Sydney Grammar School Weigall Sports Complex (SSD-10421)

Response to Request for Information

Prepared on behalf of Sydney Grammar School

15 June 2021 | 19049

Figure 5 – Streetscape character: Neild Ave (Source: AJ+C)

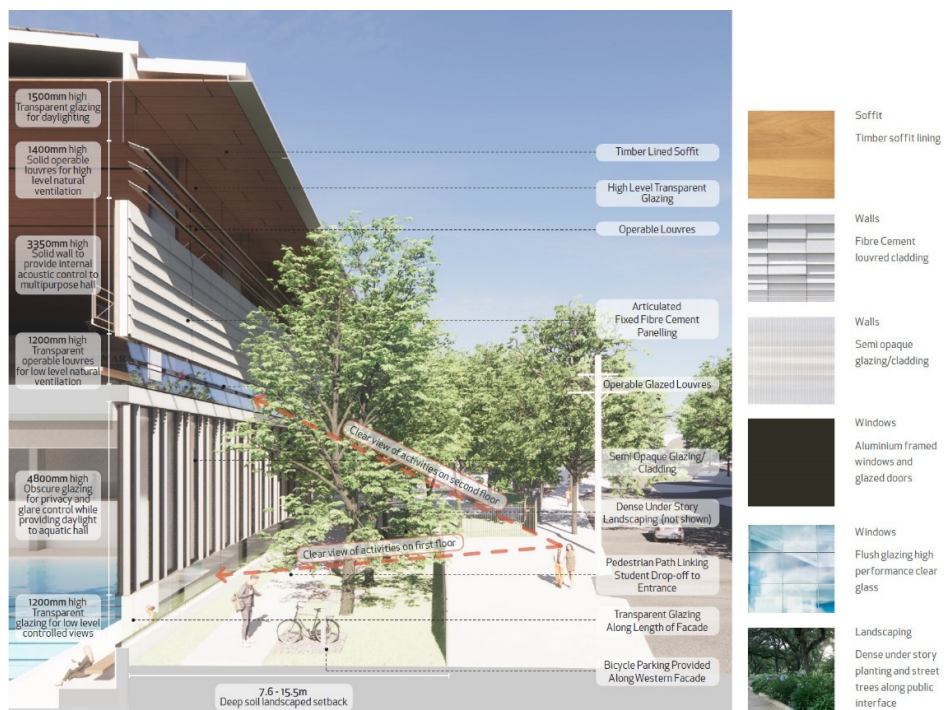
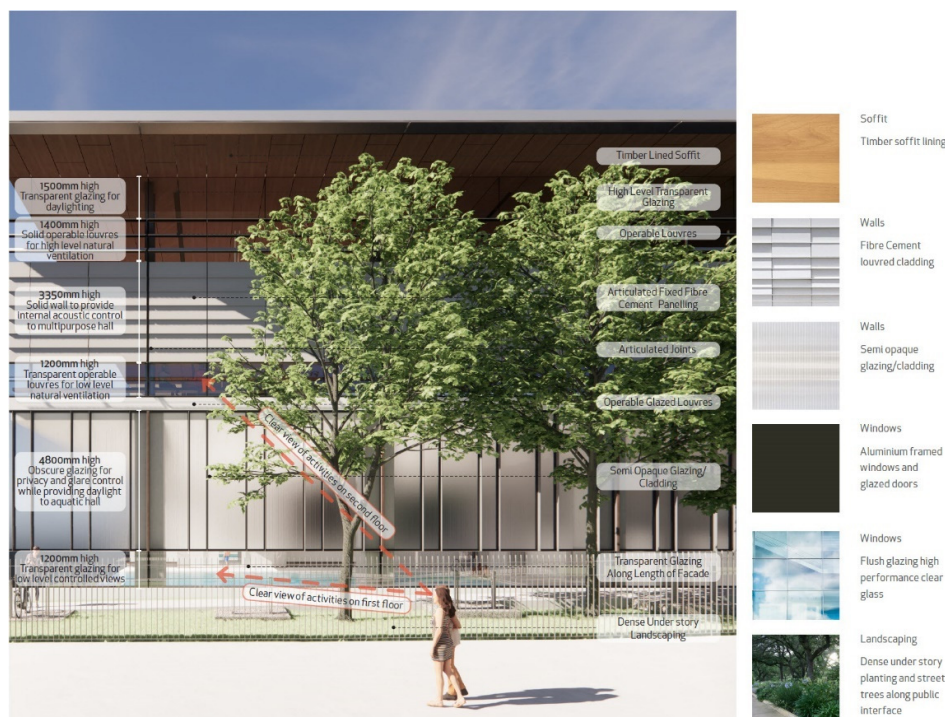
a) *The RtS has not provided a response to Woollahra Council's 'Streetscape Character' comments on page 5 of the EIS submission.*

To achieve design excellence, it is recommended that the façade is amended to provide transparent openings/windows and greater articulation of the façade. One way to achieve this is through a varied material palette of high-quality finishes and materials. A denser landscape and tree canopy would further mitigate the impacts of the deactivated part of the facade on the streetscape.

AJ+C has advised that the Neild Avenue façade includes significant openings and windows (comprising 65% of the façade area), articulation and high quality materials as detailed below and illustrated on **Figure 5**:

Significant areas of openings and windows are proposed. This includes low level clear glazing, mid-level obscure glazing, operable glazed louvres, operable solid louvres and high level clear glazing. These components make up approximately 65% of the façade area while balancing the functional requirements of solar and glare control, internal acoustic control to sporting functions and privacy/overlooking.

A significant deep soil setback to Neild Avenue of 7.6-15.5m accommodates existing significant trees, proposed trees and under storey planting, visitor bicycle parking and internal site footpath connection.

Figure 7 – ADG Figures 3A.6, 3F.3 and 3F.6: Equitable distribution of building separation distances

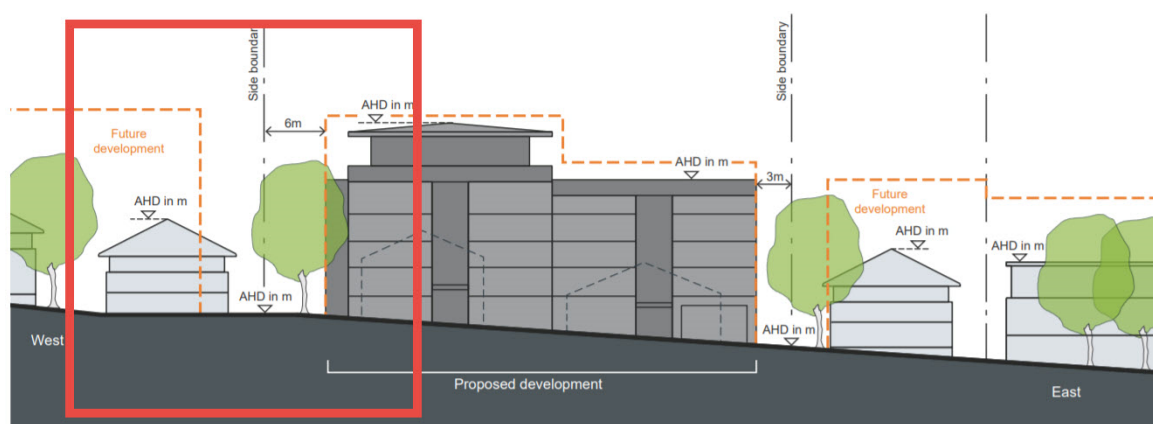
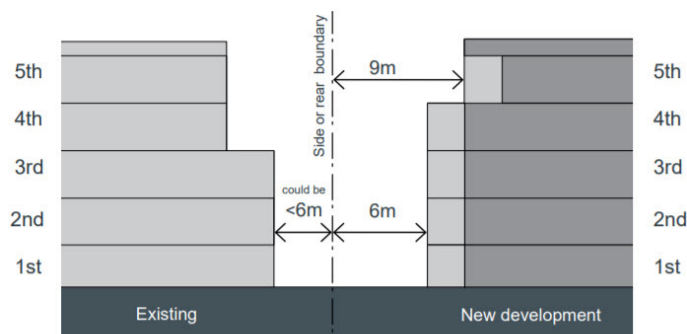
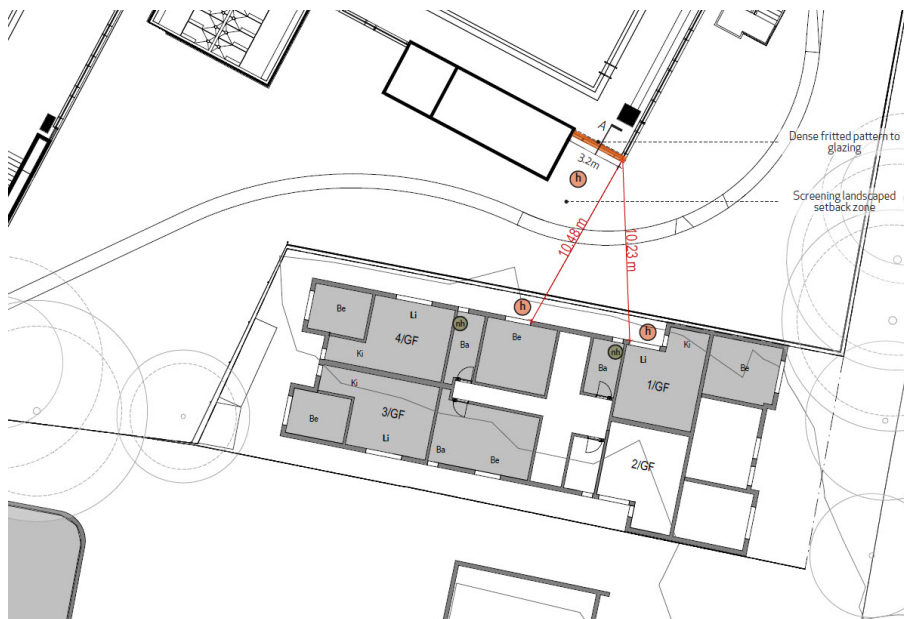
- a) Confirm the percentage of overshadowing of the rear private communal open space between 29-33 Lawson Street south of the site, to demonstrate compliance with the minimum ADG solar access to private open space (min 50% for 2 hours in mid-winter).
- b) Provide further justification as to why the building separation between 8 Vialoux Street and the Building 1 is considered to be acceptable although the distance, being 10m, does not comply with the minimum 12m requirement of the ADG.

This equitable sharing of building separation distances is also illustrated at ADG Figures 3A.6, 3F.3 and 3F.6 which are copied below at **Figure 7**. The ADG figures consider conditions when the adjoining development does not comply with the ADG building separation distances (consistent with existing circumstances near the site where windows to the existing residential flat building at 8 Vialoux Avenue have a setback of 1.5m when the ADG requires 6m). In these circumstances, the ADG does not oblige a new development to compensate for an existing non-compliance. Applying the ADG guidance as it would apply to a residential flat building, a setback of just 6m is required for habitable rooms in Building 1. With setbacks of more than 8.5m proposed, Building 1 fully complies with the ADG.

If the equitable distribution of building separation is put aside, a small section of Building 1 is below the 12m habitable to habitable room separation requirement of the ADG (see plan and section at **Figure 8** and elevation at **Figure 9**). The non-compliance comprises a fixed window to the programme pool area (3.2m long x 1.25m high located 1.45m above the internal floor level). The privacy impact of this window would be minimal and reasonable for the following reasons:

Figure 10 – MRV swept path (Source: ptc)

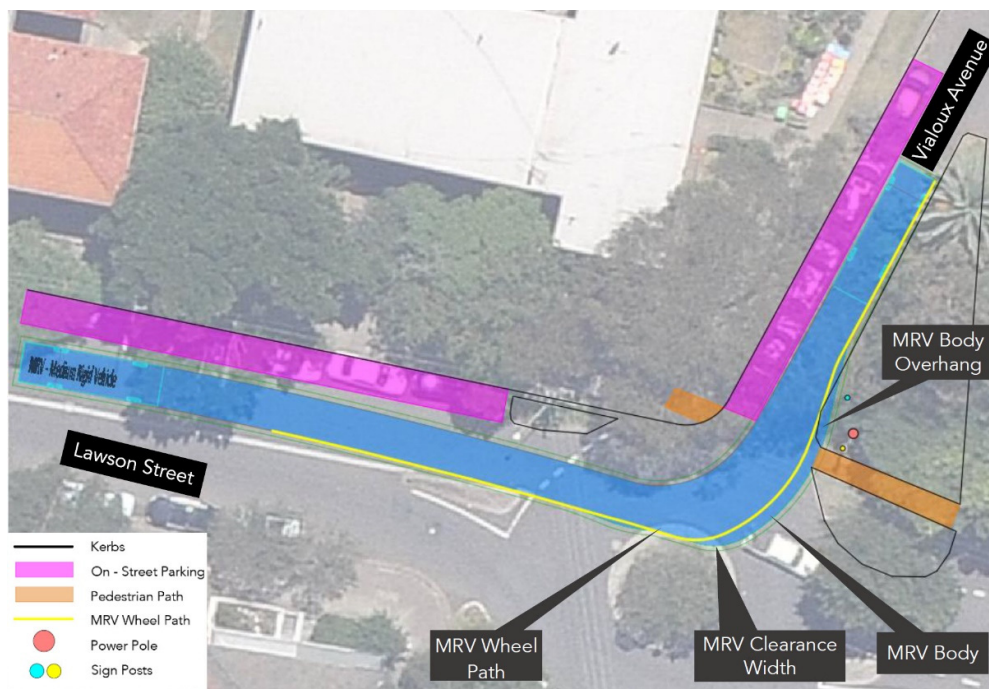
- a) *Update Appendix V Construction Management Plan (page 13) construction hours to be consistent with the hours noted in the EIS (page 154) and the Noise Assessment Report (page 37).*
- b) *Provide further details to demonstrate that medium rigid vehicles (as specified in the EIS) and other construction trucks will be able to manoeuvre from Lawson Street into Vialoux Street without conflict with parked cars or the existing central island with the overhanging trees. If suitable truck access is not achievable, suggest an alternative construction truck entry point for the site.*

The additional traffic information provided by ptc (**RFI Appendix H**) confirms that a Medium Rigid Vehicle (**MRV**) is the largest anticipated vehicle entering the site off Vialoux Avenue. ptc has considered the physical constraints at Lawson Street and Vialoux Avenue and concludes that:

- An MRV will not obstruct any on-street parking
- The body of an MRV would slightly overhang the median island on Vialoux Avenue; however, there is sufficient clearance between the vehicle and the sign posts / power pole.

(See MRV swept paths at **Figure 10**).
